CITY OF KOTZEBUE
ITB #15-12
SWAN LAKE HARBOR FACILITY IMPROVEMENTS

SUBJECT: **Addendum No. 2**

CITY OF KOTZEBUE
SWAN LAKE HARBOR FACILITY IMPROVEMENTS
 KOTZEBUE, AK

SWAN LAKE HARBOR FACILITY IMPROVEMENTS
 KOTZEBUE, AK
FLOAT DETAILS

1 TYPICAL MODULE LAYOUT
 SCALE: 3/4" = 1'-0"

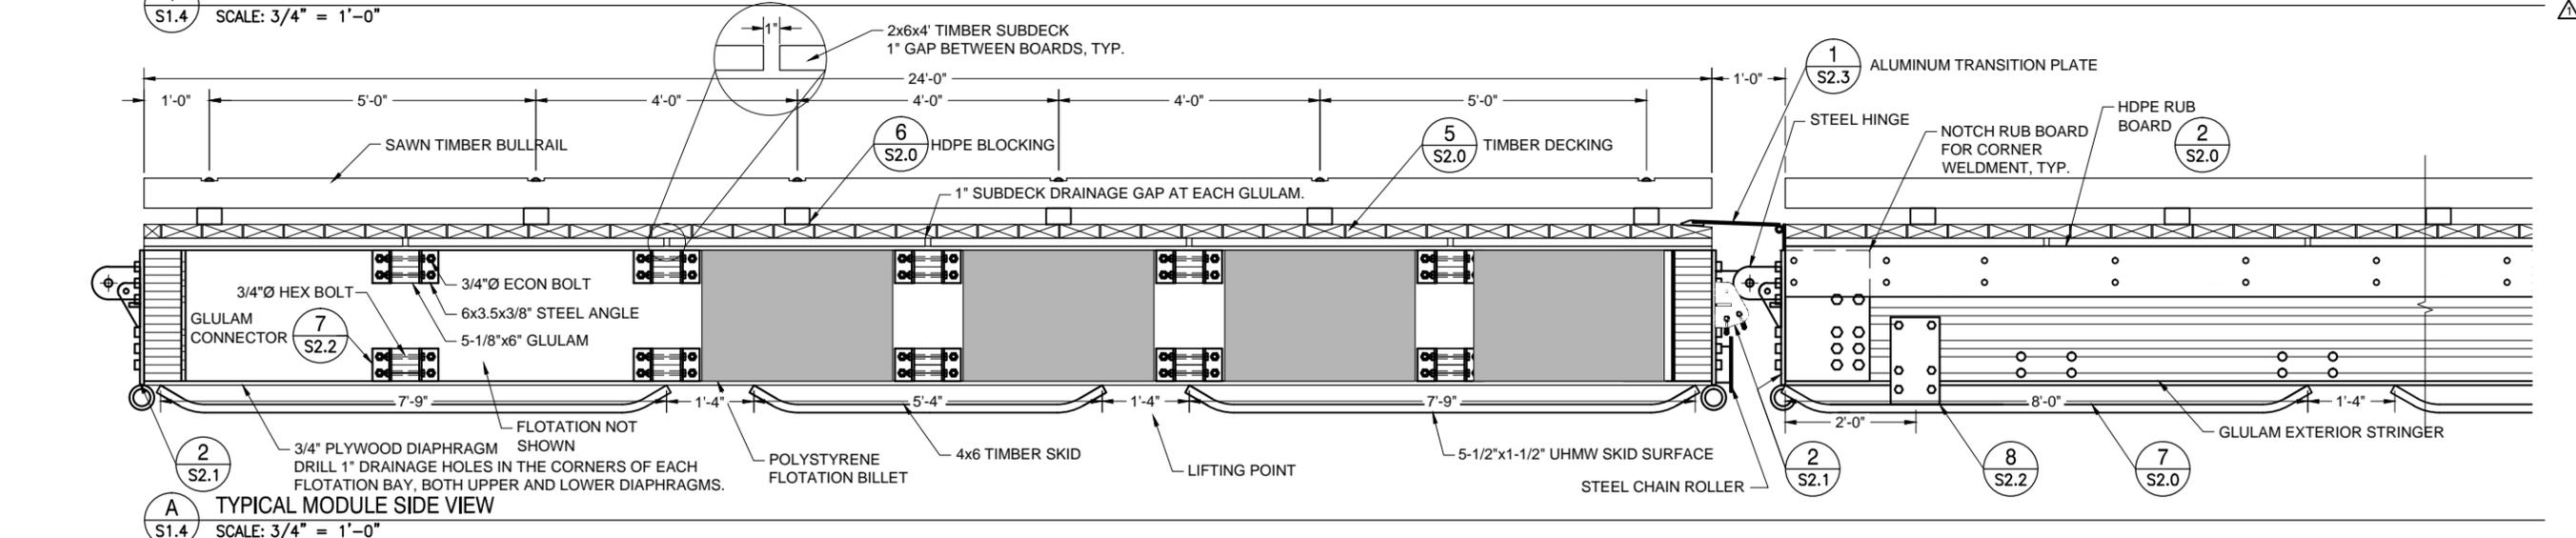
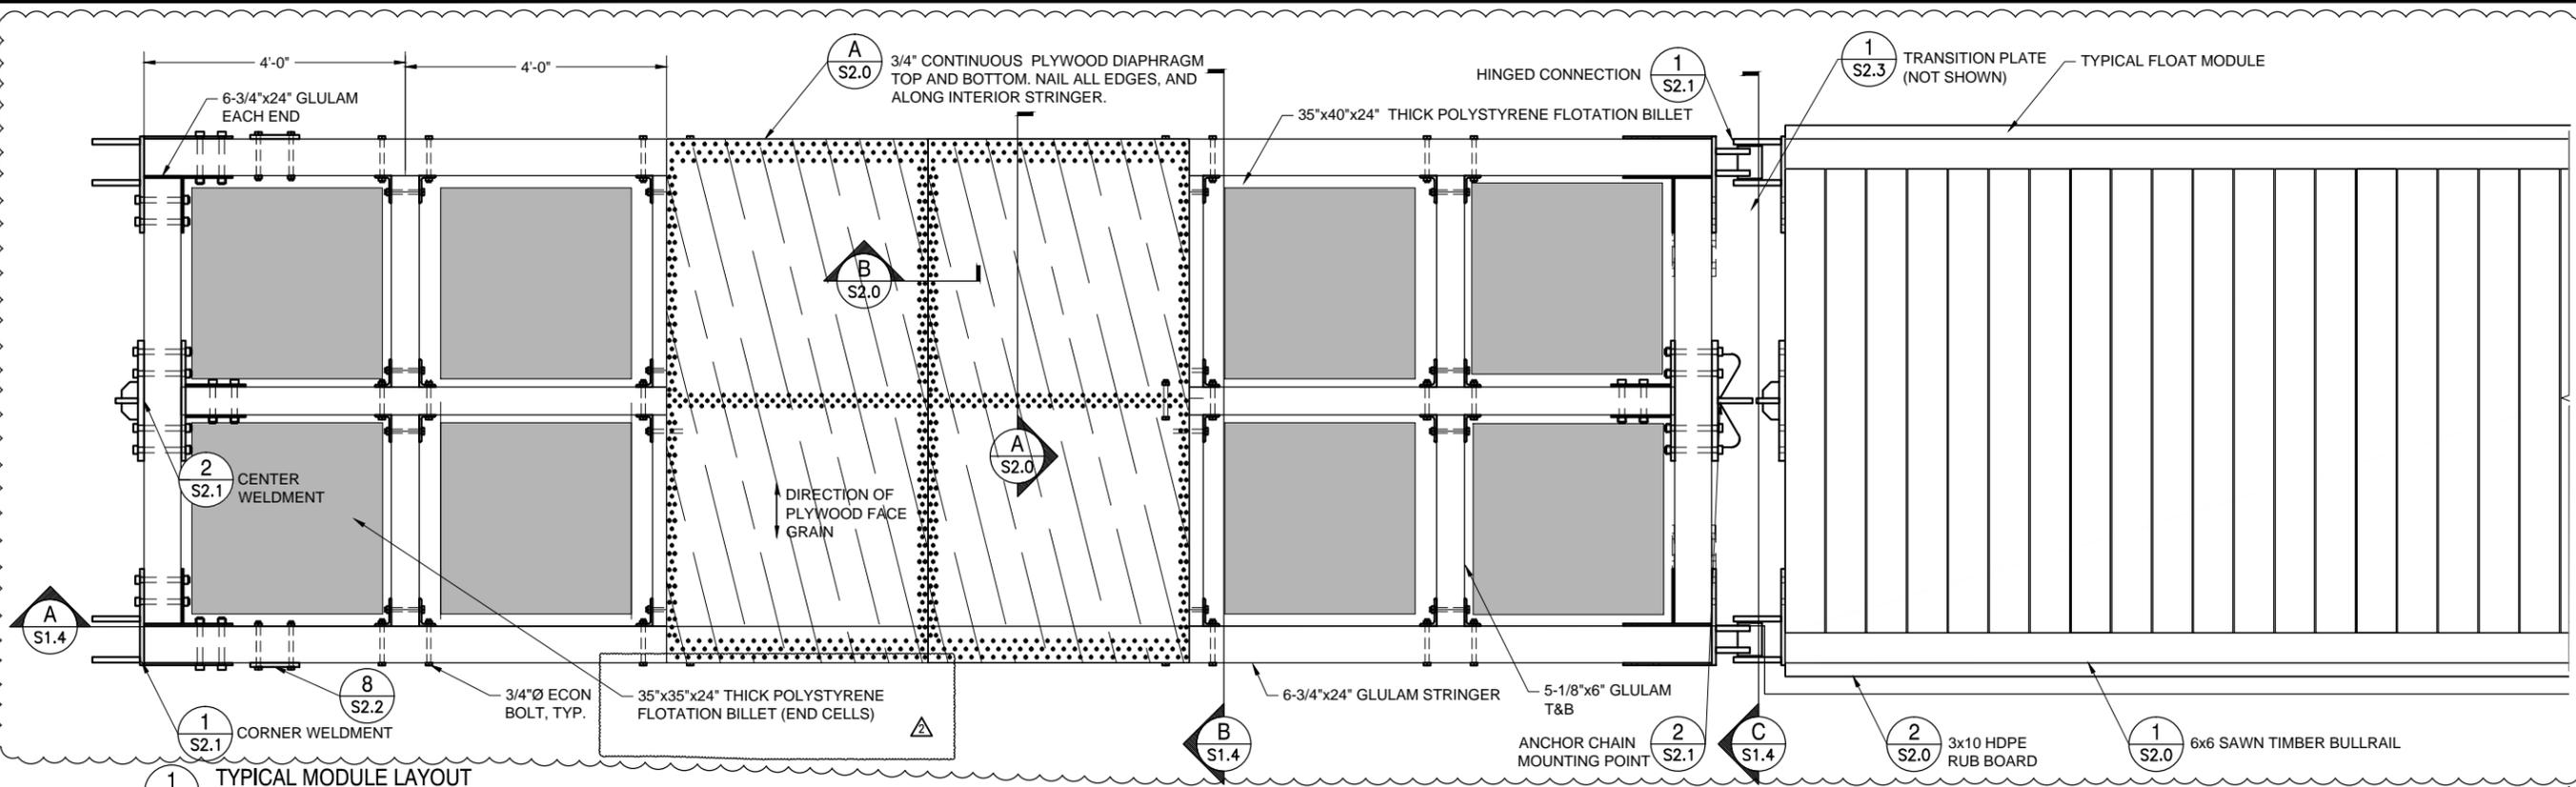
Q20. Sheet S1.4 Detail 1 – Floatation Billets are called out as 35"x35"x24" in the end of the float module, but called out at 35"x40"x24" further into the float? Are there varying sizes of foam within the floats or is this a typo? (Floats Billets all scale to 35"x35"x24").

Reply: Leader Revised on this sheet to note the end cells.

1	Plan Sheet S1.4	Leader for End Floatation extended
2	Plan Sheet 2.0	Detail 3 “NOT USED”

3 **BOARDING FLOAT CLEAT**
 SCALE: 2" = 1'-0"

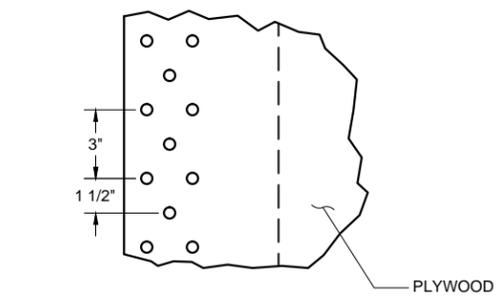
Q16. *Sheet E1.1 represents a "Boarding Float" at the launch ramp, and Sheet S2.0 indicates a cleat detail for a "Boarding Float". However, we do not see a Boarding Float represented anywhere else in the plan set, nor is it indicated on the bid schedule. Please clarify*

Q21. Sheet S2.0 Detail 5 – A detail is given for cleat attachments, however I can find nowhere that this detail is called out. How many cleats are to be included and where are they to be attached?

Reply: The Boarding Float was removed from E1.1 in Addendum 1 and the Detail is noted as "NOT USED" in Addendum 2

Reply: This detail has been noted as "NOT USED"

2 LIGHT POLE BASE MOUNTING DETAIL
NOT TO SCALE

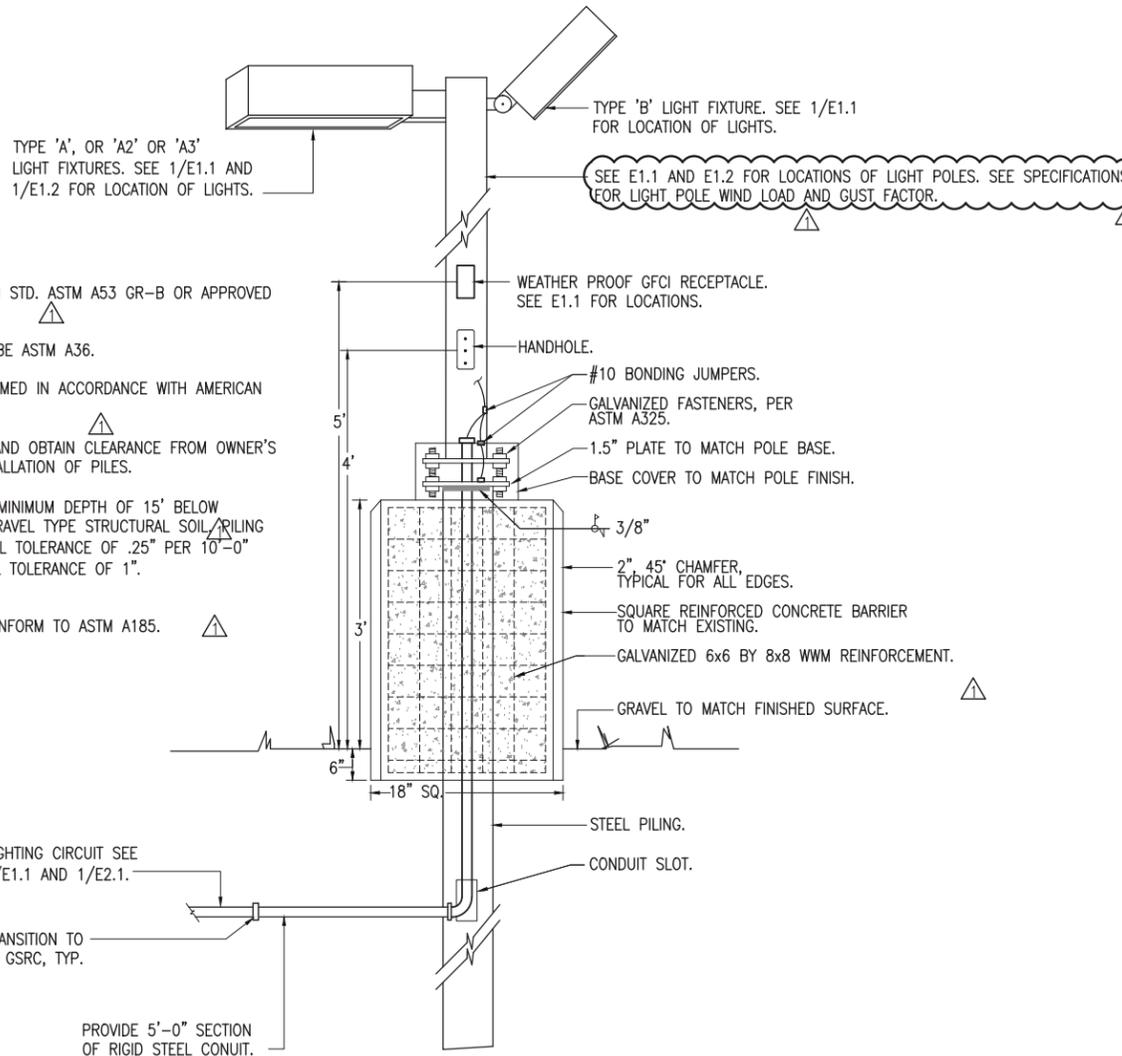
Q14. *The drawing of the light pole assembly is not to scale. Can you provide a scaled drawing of the clouded area on the attached Sheet E2.1? It is important to determine the dimensions required to ensure constructability. For example, there must be adequate clearance between the top of the concrete barrier and the bottom of the steel base plate to allow the use of slug wrenches for the turn of nut method of tightening the anchor bolt assemblies.*

Q19a. Follow up question for Addendum 1, Reply to Question 2. During the Pre-Bid meeting, you advised that the correct wind rating was listed on the Plan Sheet E2.1 Detail 2, 110 MPH with 1.3 Gust Factor. In Addendum 1, the response is 145MPH +1.3 Gust Factor. This standard is in excess of the previous conflicting design speeds listed on the plan sheet and in the specifications.

In discussions with an engineer with one of the composite pole manufacturers, this wind rating is a hurricane force wind rating and thus requiring that the poles be direct burial only. The foundation detail in the project is not for direct burial poles. Further, the engineer stated that the pole manufacturer does not determine the depth to which the pole must be buried. The design responsibility falls to the project engineers who have specific knowledge of the local soil conditions. He stated that the project engineers must determine the length of the pole portion to be buried and call out a schedule of back fill materials and a compaction schedule. Lastly, the engineer indicates that the composite pole cannot have the square concrete barrier encapsulating the first 3' of the pole above ground. This reduces the pole's bending performance.

Please provide pole direct burial specifications with design details, back fill material specifications, compaction specifications and alternate design to square reinforced concrete barrier cast around the pole. This information is necessary for electrical contractor and general contractors to properly price the installation of the poles and determine the overall length of the pole so that pole manufacturers can price the poles.

Q19b. Additional information to #19. If the wind standard were 130 MPH +1.3 Gust Factor, the composite pole could be used on the existing foundation as shown in the plans. The bases of composite poles are made of two different materials bonded together. At 130 MPH the bond strength is adequate. But at 145 MPH + 1.3 Gust Factor, that bond is inadequate thus the need for direct burial of the composite pole base. Think of this as burying a fiberglass fishing pole base in the ground and the top of the pole is where the lights would get mounted. Now think of that fishing pole flexing in the wind all of the way down to the base in the ground to achieve maximum load strength. If you are fighting that big king salmon on your favorite fishing rod, the entire length of the rod acts as a shock absorber and works along with the strength of the line to help you land the fish. And this is why you hang onto the end of the rod. Now if you grab onto the rod higher up, you suddenly lose much of the fighting strength of the rod and risk losing that prize fish because now the full force of the fish is being exerted on a portion of the rod that is smaller in diameter and lower strength. That is why there cannot be a concrete parking barrier poured around the lower portion because it needs to flex in order for the full benefit of the composite structure to be realized. This all boils down to if the project spec is going to stand at 145 MPH +1.3 Gust Factor, then there must be new design work done for the direct burial of the composite pole base and new method (allowing full flex of the pole shaft) to protect the pole once installed. If the spec goes to 130 MPH +1.3, then the existing foundation is compatible with composite poles. If staying at 145 MPH +1.3 Gust Factor and round tapered steel poles are allowed as a substitute, then the existing foundation design and concrete protection are compatible. I am not advocating one way or the other, simply informing you that the current design of composite pole and 145MPH +1.3 Gust Factor cannot be built as designed in the documents.

Reply: The electrical plans and details are diagrammatic and not to scale; this is a constructability issue that the contractor is responsible for.

Reply: The. Spec 265600 section 2.3 B is replaced with: Wind Load: AASHTO "Standards Specifications for Structural Supports for Highway Signs, Luminaires, and Traffic Signals," 6th Edition, 2013, with the 2015 Interim Revisions (published in 2014--a free download from AASHTO), using the following parameters: • basic wind speed: 120 mph • recurrence interval: 50 years. For Pole foundation, Contractor to provide design of pole foundation based on provided geotechnical report.
